#### GULF OF ADEN.

Aden Outer Harbour-Decreased depths.

No. 319 (first publication).—The following particulars, etc., relative to the above, issued by the British Admiralty (No. 1178 of 1921), are republished:—

Chart affected .- No. 7, Aden harbour and approaches.

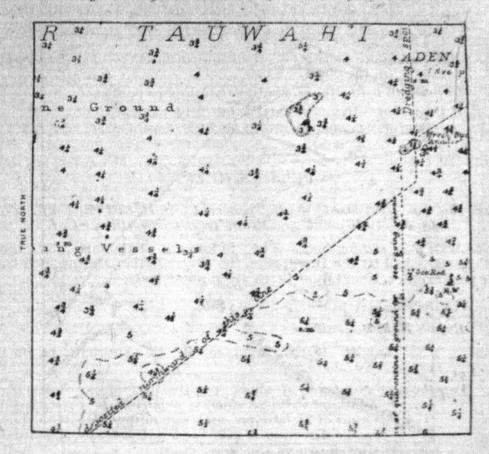
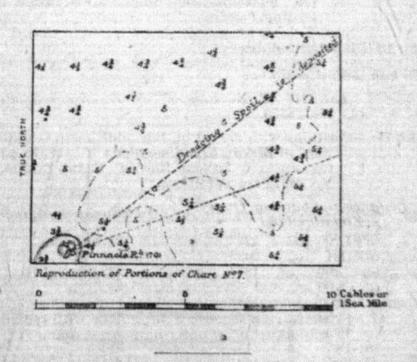
Details.—The accompanying reproduction of portions of chart No. 7 shows the necessary corrections with regard to decreased depths in the outer harbour at Aden.

Remarks.—It is intended to mark the 4½-fathom (7m8) patch, situated about 1½ mfles north-eastward of Pinnacle rock, by a b'ack can buoy, concerning which further Notice will be given.

> Chart affected .- No. 684, Mto Mtwara and Mikindani harbours, with

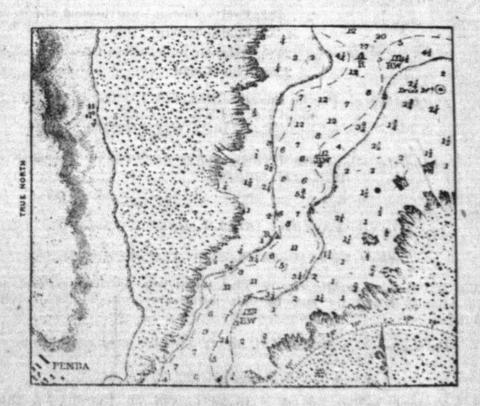
> Position.—Pemba, lat. 10° 15' S., long., 40° 08' E. (approx.). Details.—The accompanying reproduction of two portions of the plan of Mikindani harbour entrance on chart No. 684 shows the necessary corrections to that plan with regard to buoyage.

Charts affected .- No. 2265, Kobe and Hyogo bays.

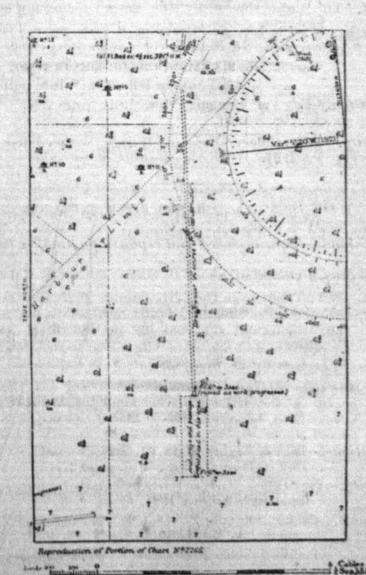
Details.—The accompanying reproduction of a portion of chart No. 2265 shows the projected limits of a detached breakwater in course of construction together with an area which is marked by light-buoys and within which anchorage and passage are prohibited; the prohibited area will be extended, and the northern light-buoy moved, as the work advances.

Charts affected.—No. 1884. Arakan river, with plan.
,, 1369, Mayu river to Kyank Pyu harbour.

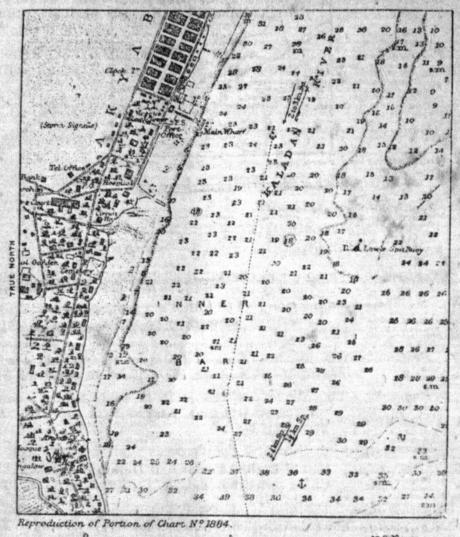
Details .- Amendments to the charts with regard to depths on the inner bar and vicinity, consequent upon a recent survey, are shown on the accompanying reproductions of portions of charts Nos. 1884 and 1369.

> From the reproductions it will be observed that a general decrease in depths has taken place; the survey, as shown, revealed a least depth of 20 feet (6 " 1) on the inner bar April 1921.

Charls affected .- No. 1969, Ozuchi jima to Funoko sima.

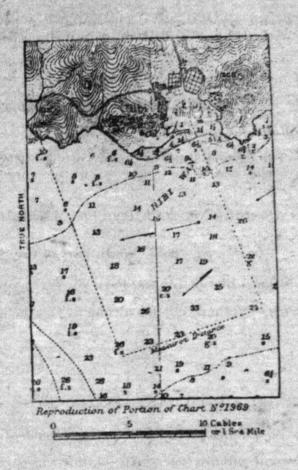
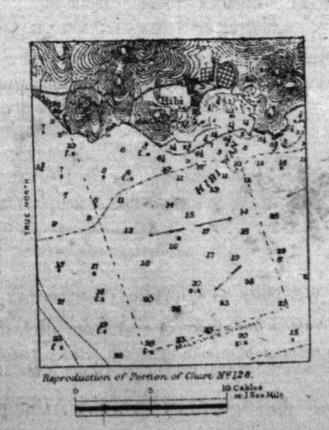
Details.—The harbour works at Hibi wan have now been completed and a measured distance, indicated by beacons, has been established as shown on the accompanying reproduction of portions of charts Nos. 1969 and 128.

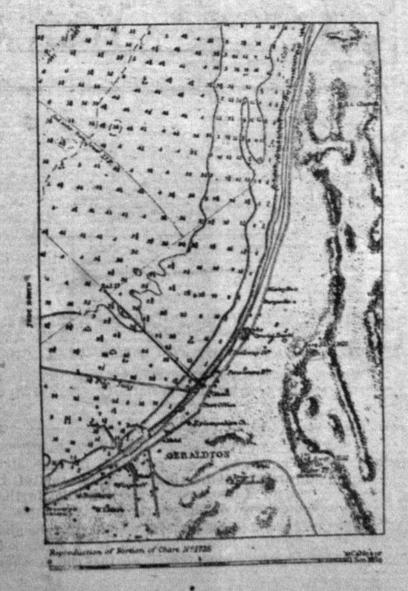
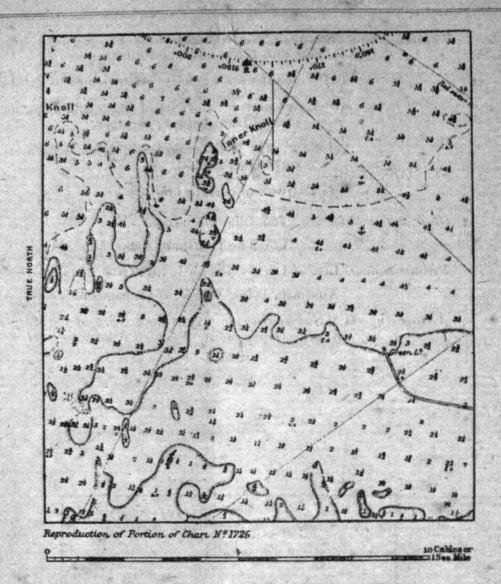
Details.—The accompanying reproductions of portions of charts Nos. 1725 and 1723 show the following:—

- (a) Amendments to charts with regard to shoals.
  - (b) Extension of the North jetty and amended posi-tion of front leading light.
- (c) New pile jetty completed, from which a green light is exhibited.
- (d) Position of certain landmarks.

Charts affected .- No. 2376, Plan of Port Ta kau.

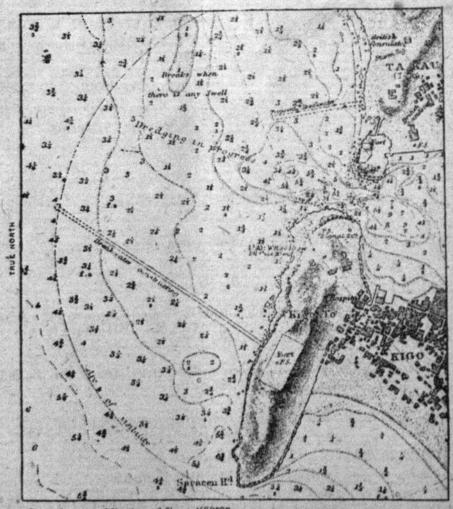
Details.—The accompanying reproduction of a portion of the plan of the Port of Ta kau on chart No. 2376 shows the following:—

- (a) Breakwater constructing southward of the entrance.
- (b) Proposed breakwater northward of the entrance.
- (c) Light exhibited at entrance.

Chart affected .- No. 1460, Plan of Dilhi harbour.

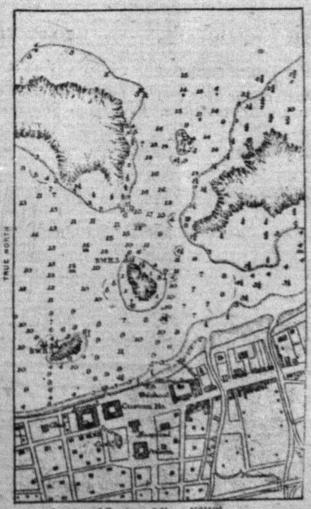
Details.—The accompanying reproduction of a portion of the plan of Dilhi harbour on chart No. 1460 shows the necessary corrections to that plan with regard to the positions of buoys and beacons; the positions given are approximate and a note to this effect is to be inserted under the title of the plan.

Charts affected.—No. 8d, Red sea, sheet 4. 2523, Red sea.

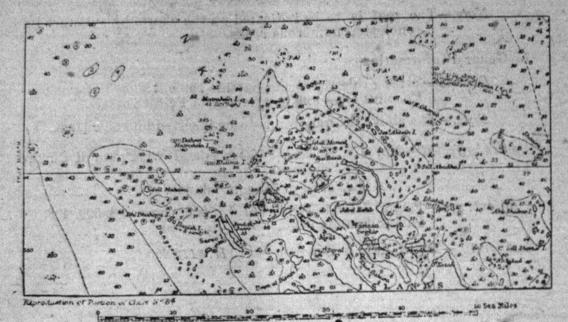
Details.—The accompanying reproductions of portions of charts Nos. 8d and 2523 show the necessary corrections to those charts with regard to heights and positions of various islets, and depths in the vicinity of the Farisan islands.

Charts affected .- No. 2637, South part of the Strait of Makassar.

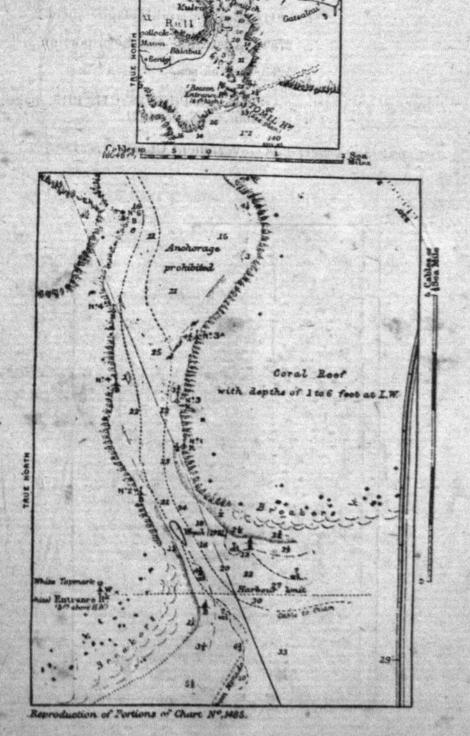
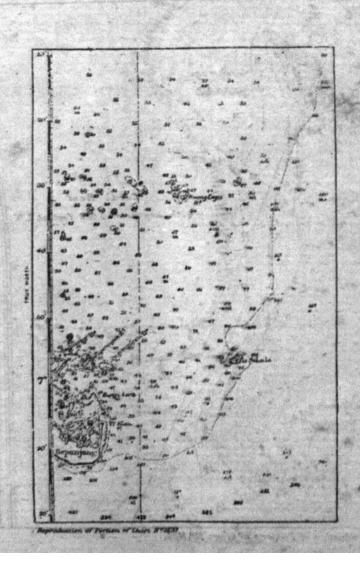
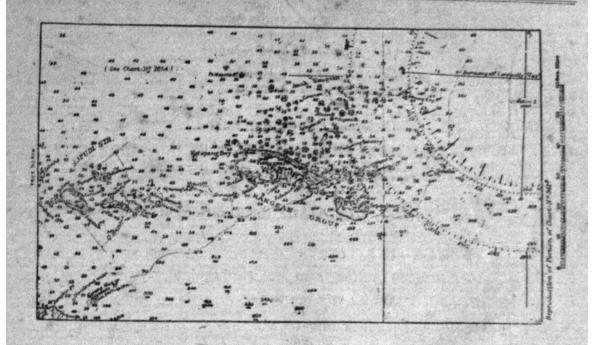
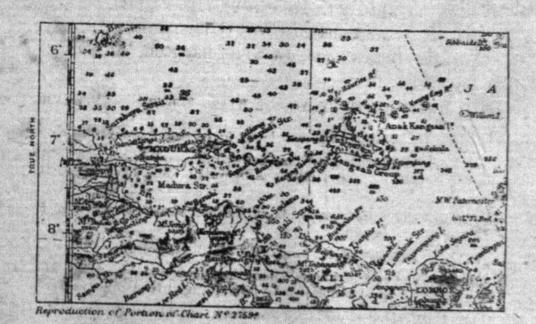
Details.—General amendments to Charts Nos. 2637, 941b, 2759a, and 1263 with regard to the coast line of the Kangean group of islands and the depths and shoals in their vicinity are shown on the accompanying reproductions of portions of those charts.

Remarks.—These corrections have been embodied in a new edition of chart No. 1654 which has recently been published.

Charls affected .- No. 2467, Plan of Jende road.

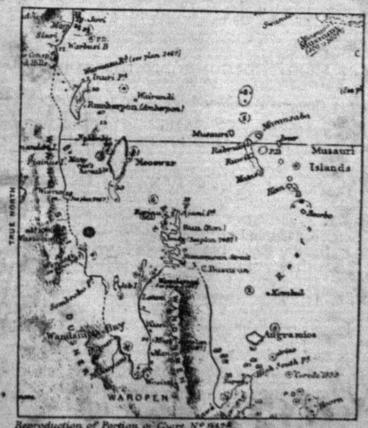
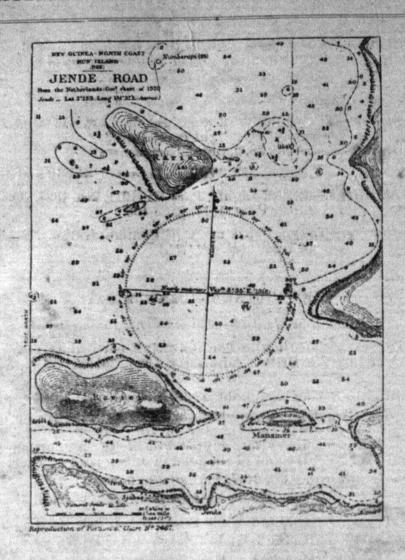
Details.—Amendments to charts with regard to coastline, depths and shoals in the vicinity of Run island are shown on the accompanying reproductions of a portion of chart No. 9426 and of the plan of Jende road on chart No. 2467.

Charts affected.—No. 942a, Eastern archipelago—sheet 3.

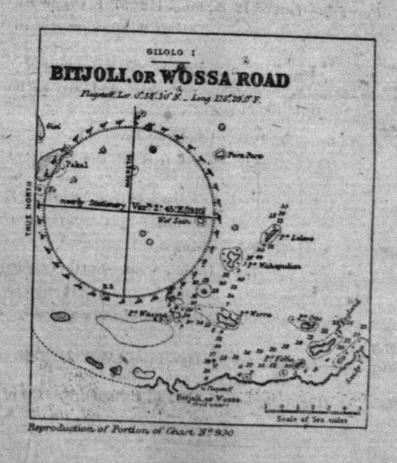
Details.—The accompanying reproduction of a portion of chart No. 942a and of the plan of Bitjoli or Wossa road on chart No. 930 shows the necessary corrections to those charts with regard to reefs in Wossa bay.

Remarks.—It will be observed that the reef, formerly shown on the charts about 2 miles north-eastward of Pulo Leleve, does not exist and has been omitted from the reproduction.

Reproduction of Portion of Churt Nº1648

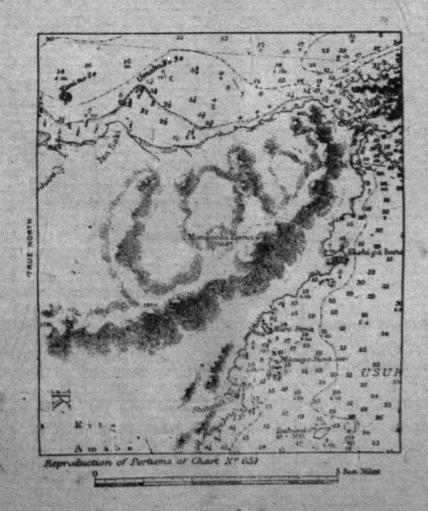
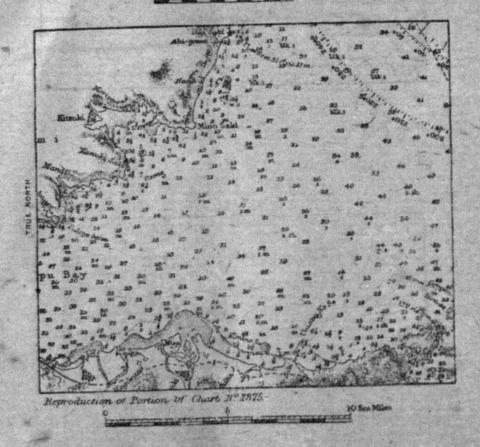
Details .- Amendments with regard to shoals in Beppu and Usuki bays are shown on the accompanying reproductions of portions of charts Nos. 651, 2875 and 1648.

Chart affected.—No. 927, Plan of Maluso bay.

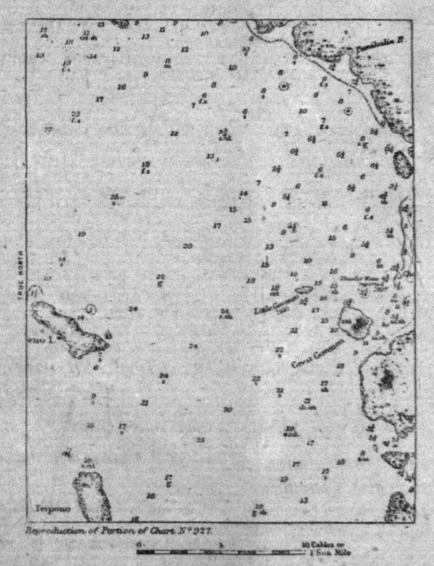
Details.—The accompanying reproduction of a portion of the plan of Maluso bay on chart No. 927 shows the necessary corrections to that plan with regard to rocks and shoals.

Chart affected.—No. 978, Kusaie or Ualan island, with plan of Chabrol harbour.

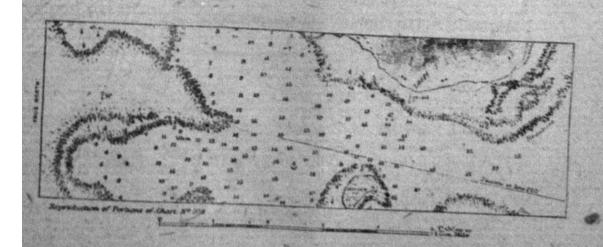
Details.—The accompanying reproduction of portions of chart No. 978 and the inset plan of Chabrol harbour shows the necessary corrections to that chart with regard to the positions of beacons.

Charts affected .- No. 1017, Gabo island to Montagu island.

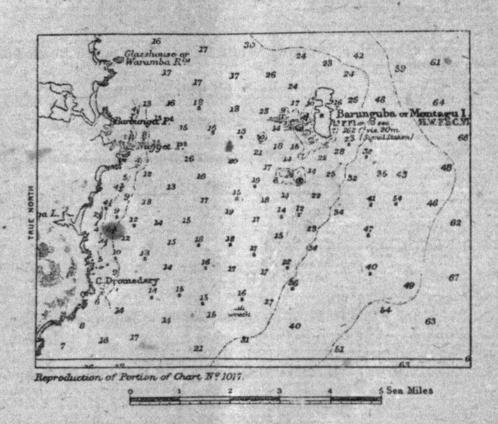
Remarks.—It will be seen from the reproduction that no trace was found of the 2½-fathom shoal marked "(P.D.)" southeastward of Montagu island. This shoal is to be expunged from chart No. 1211.
